**MPC Paper No. 3/19**

**Submission for Compliance with  
Approval Condition (j) of Application No. A/H4/94**

**Proposed Alteration and Modification Works to the Building  
and External Façade for Cultural/Leisure/Retail/Food &  
Beverage Uses/Open Space/Ancillary Support, for the Central Market  
Revitalization Project in “Other Specified Uses” annotated  
“Building with Historical and Architectural Interests Preserved for  
Commercial, Cultural and/or Community Uses” Zone,  
The Former Central Market, 80 Des Voeux Road Central, Central, Hong Kong**

繪圖  
DRAWING  
AA - 1

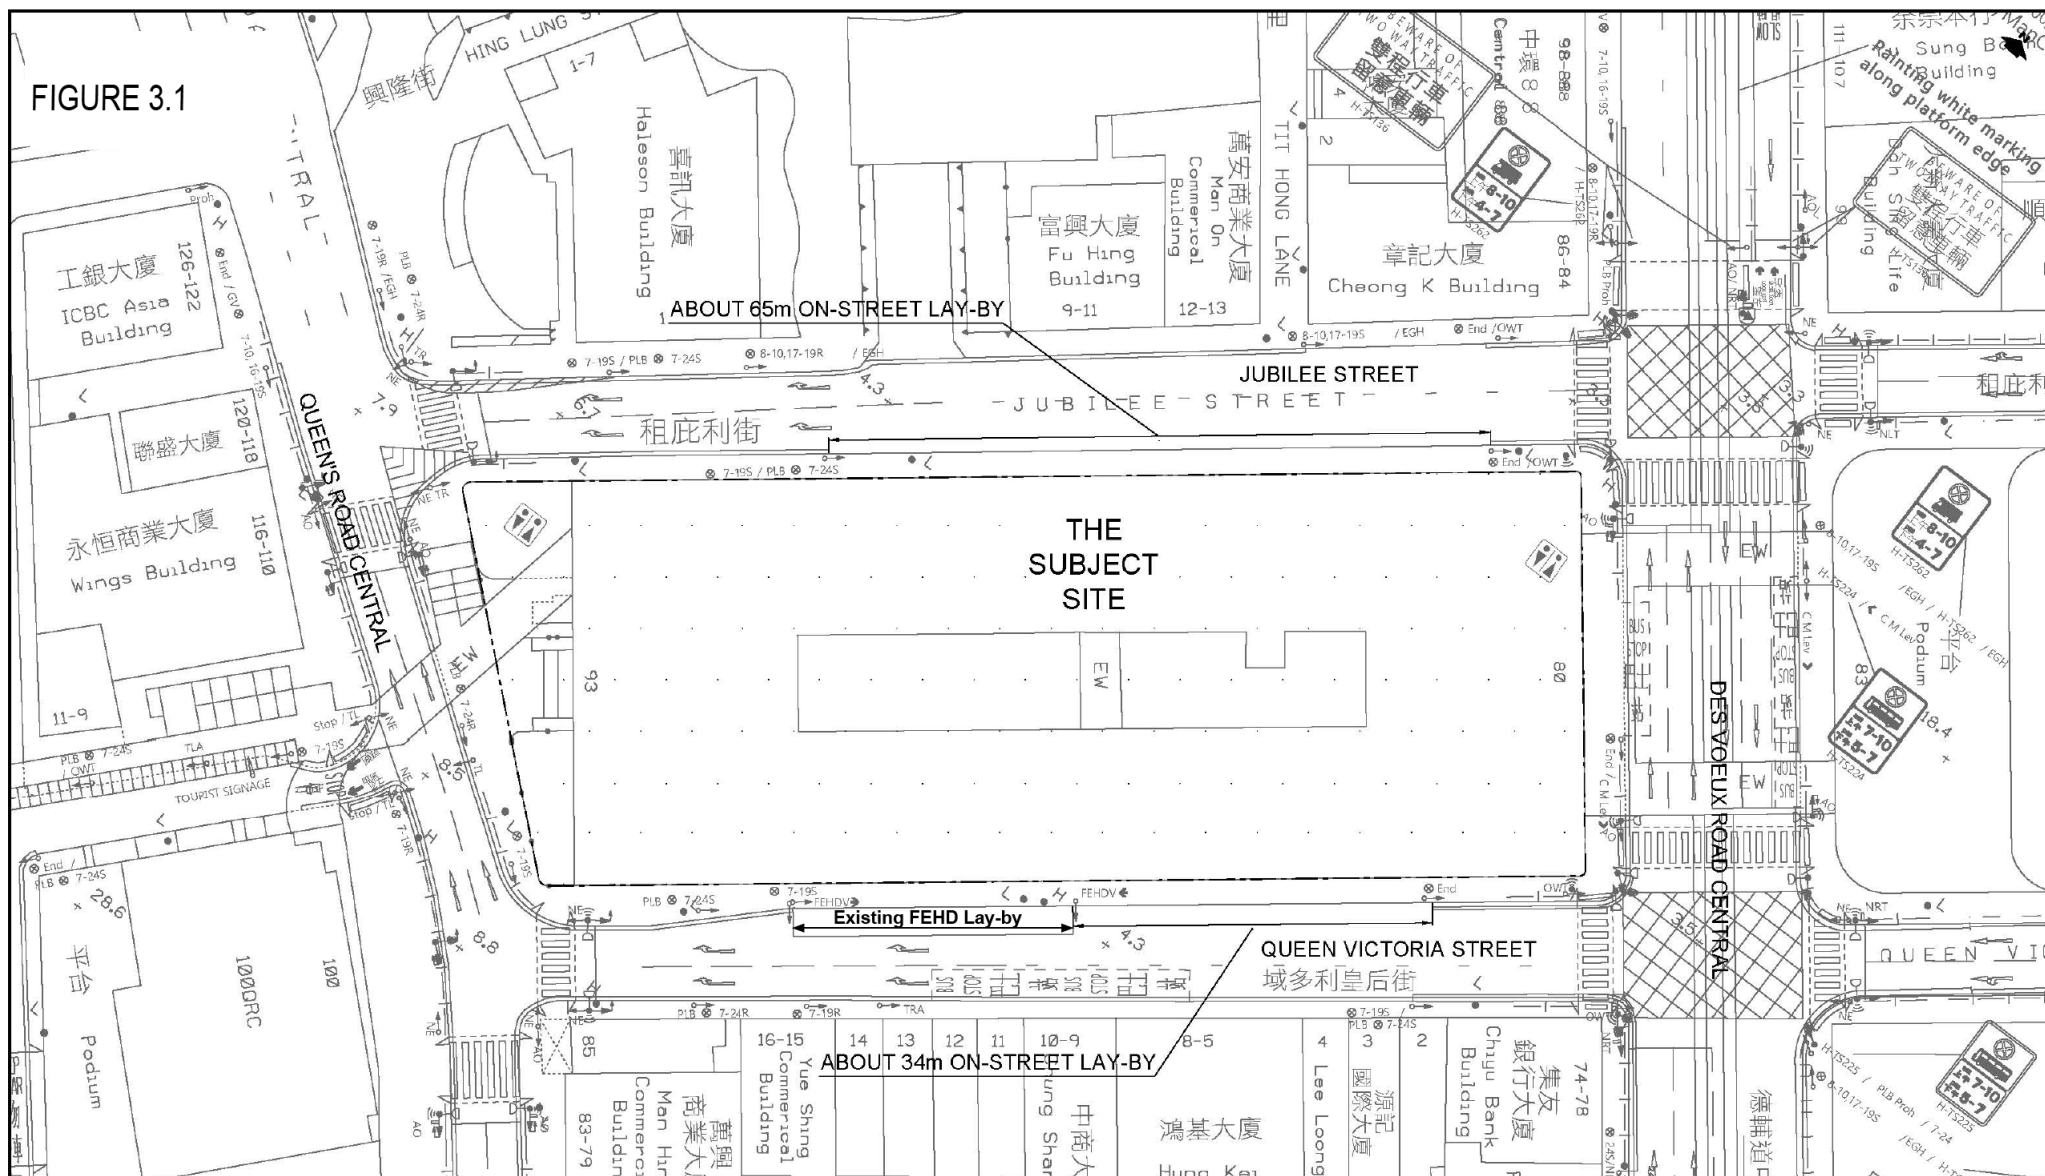
- (a) conversion of a section of road carriageway on the western side of Queen Victoria Street (about 26m) to pedestrian pavement with a width of about 4.95m including planting (**Drawings AA-1 and AA-2** and photo 4 on **Plan AA-4**);

- (b) extension and conversion of an existing 28m long lay-by reserved for the Food and Environmental Hygiene Department (FEHD) vehicles on Queen Victoria Street (**Drawing AA-1**) to a 34m public lay-by for loading/unloading activities (**Drawing AA-2**). The FEHD lay-by is proposed to be reprovisioned separately at Eastern Street North (21m) and Pier Road (7m) respectively (**Drawings AA-8 and AA-9**);

- (d) to retain an existing lay-by of about 65m on the eastern side of Jubilee Street (**Drawing AA-1**);
  - (e) to plant four trees (*Polyspora axillaris* 大頭茶) along the widened pavement of Queen Victoria Street and to retain the existing two trees on the pedestrian pavement along Queen's Road Central (**Drawings AA-2, AA-4 and AA-5** and photo 4 on **Plan AA-4**); and

No comment on the footpath widening proposals from the traffic engineering point of view, provided that 34m and 65m long lay-bys are maintained at Queen Victoria Street and Jubilee Street respectively.

繪圖  
DRAWING  
AA - 2

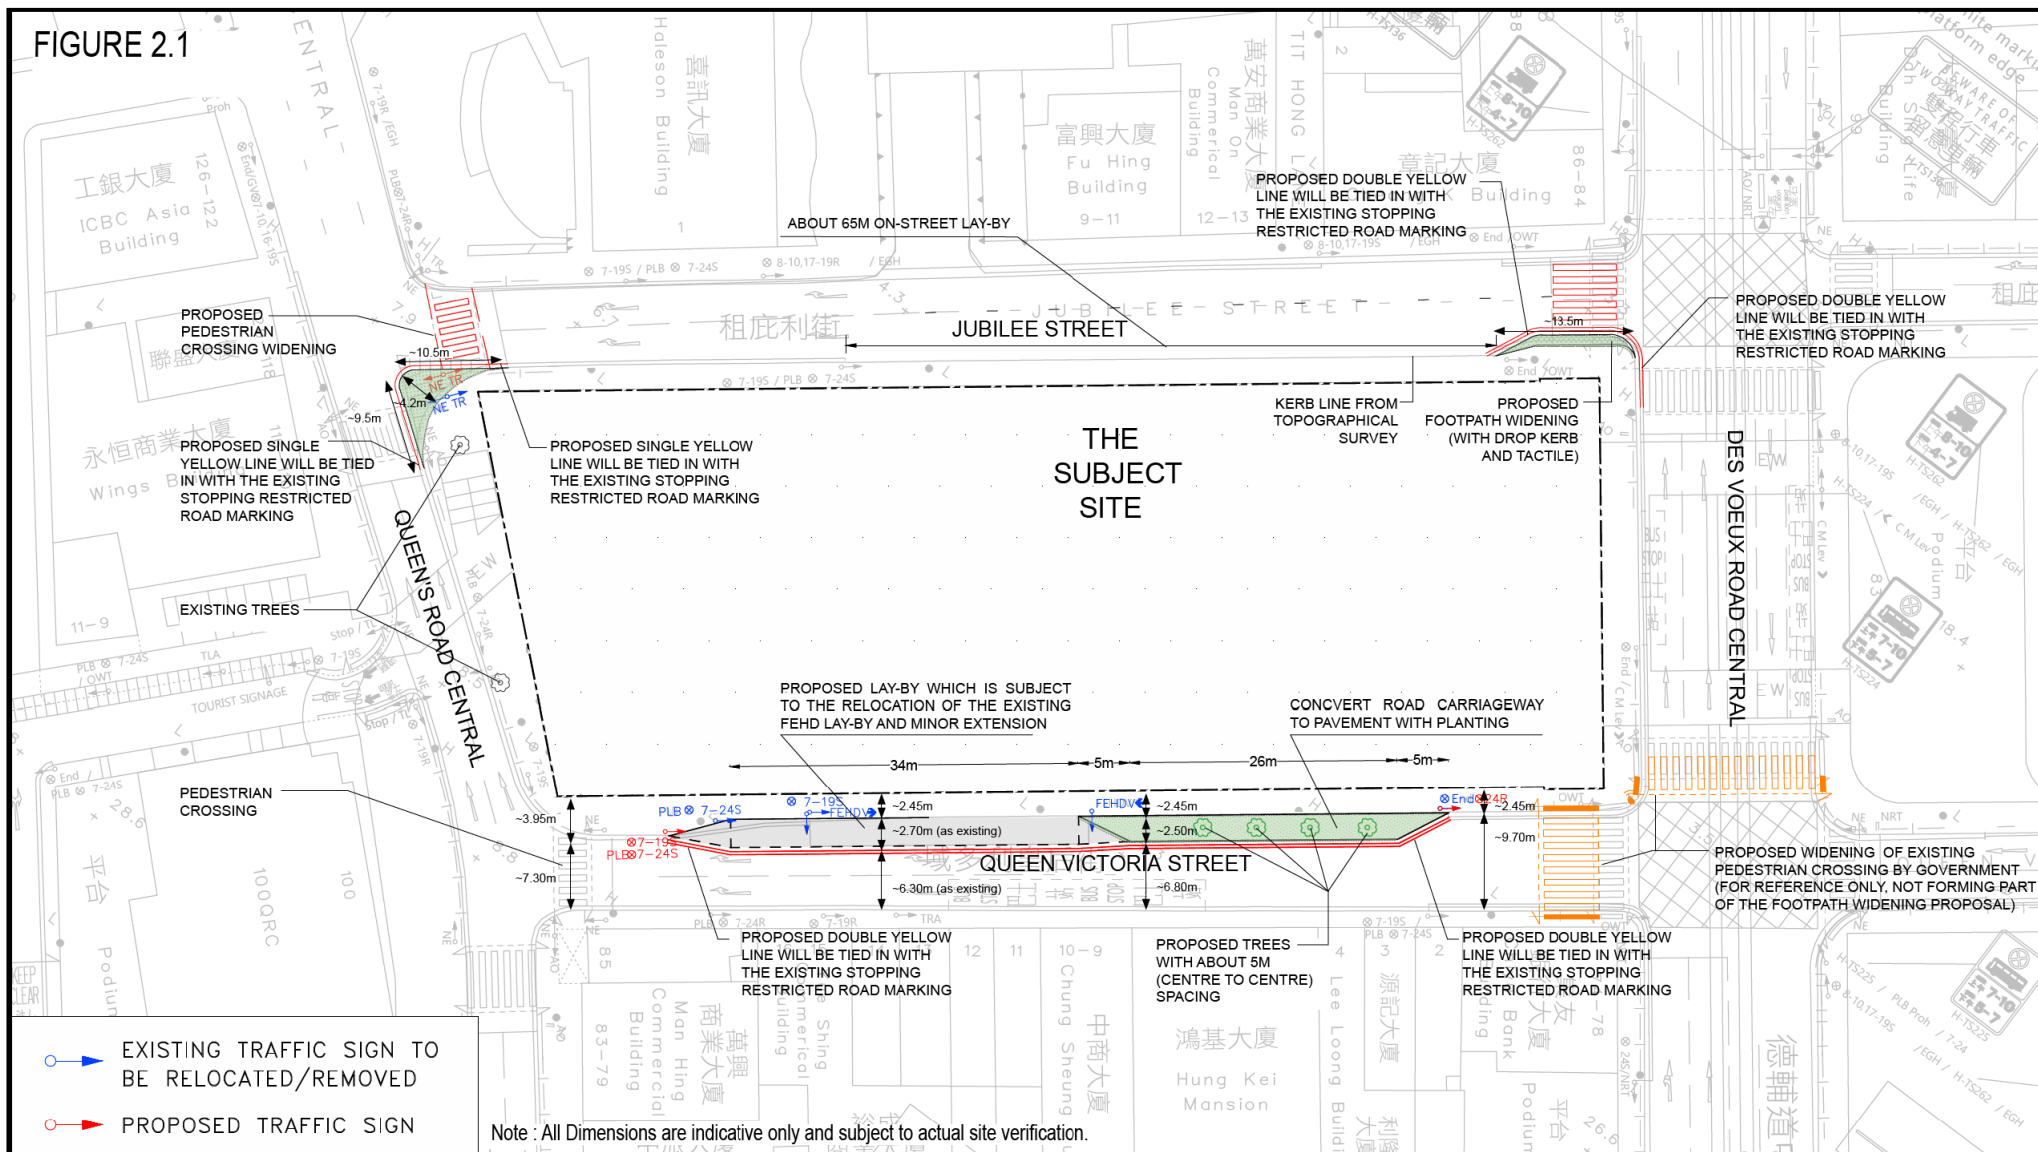
- (c) widening of pedestrian pavement at the junctions of Jubilee Street/DVRC and Jubilee Street/Queen's Road Central respectively (**Drawing AA-2** and photos 2 and 3 on **Plans AA-3 and AA-4**);

繪圖  
DRAWING  
AA - 4

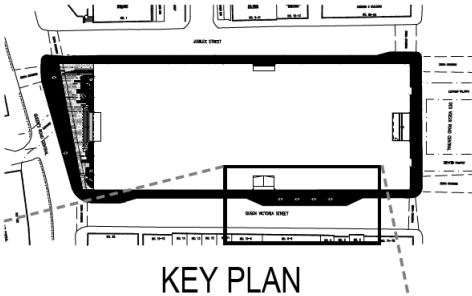
- (v) it is noted that *Polyspora axillaris* (大頭茶) will be planted on the footpath on Queen Victoria Street. The applicant should ensure the mature tree spread and tree roots would not adversely affect the proposed Grade 3 historic building; and

No.	Department	Comments	Responses
1	Leisure and Cultural Services Department	<p>1. In accordance with DEVB TCW No.7/2015, compensatory plantings should be realistic, practical and sustainable. New plantings should be carefully selected to ensure that they are compatible with the newly developed site. The principle of "right tree for the right place" should be adhered to so that trees are selected to match the site, environmental conditions and design intent. Above and below ground space should be sufficient to cater for establishment (i.e. clearance to adjacent buildings, structures, roads, other mature trees and underground utilities for root growth and anchorage) and healthy growth of the tree species selected.</p> <p>2. In general, the standard tree pit size is at least 1.5m x 1.5m. It seems that the pedestrian flow may be obstructed in these locations and also some utilities/ adjacent buildings are found very near in the proposed locations (i.e. Fresh Water Main, Electric &amp; Telecom Cable, Public Lighting Cable etc in Appendix E) and it may not provide enough spacing to accommodate the compensatory plantings and future establishment/ growth of mature trees (<i>Ficus benjamina</i> 'variegata').</p> <p>3. Please seek views from TD, HyD and Police for the technical advice on the proposed tree planting locations and HyD consent on future</p>	<p>1. While the principle of DEVB TCW No. 7/2015 on Tree Preservation is duly noted, the said Technical Circular is mostly applicable to compensatory planting after an existing tree was removed from the site. The trees proposed on the widened footpath along Queen Victoria Street in the current footpath widening proposal are new trees. Underground utility survey was also conducted to ensure sufficient below ground space for tree establishment. Tree species proposed would have a yellowish white-margined leaves, which is in-line with the "Heart of Gold" theme adopted for Central District in the Government's Greening Master Plan (GMP).</p> <p>2. The proposed tree pit size (1.2m x 1.2m) were referenced from HyD Standard Drawings Nos. H5139, H5140 and H5141. The growth of proposed trees <i>Ficus Benjamina</i> 'Variegata' would be controlled by regular pruning to control its spread and height to ensure they would not obstruct pedestrian flow or adjacent buildings. In view of the above, the proposed typical tree pits should be adequate to accommodate the proposed trees.</p> <p>3. Noted</p>
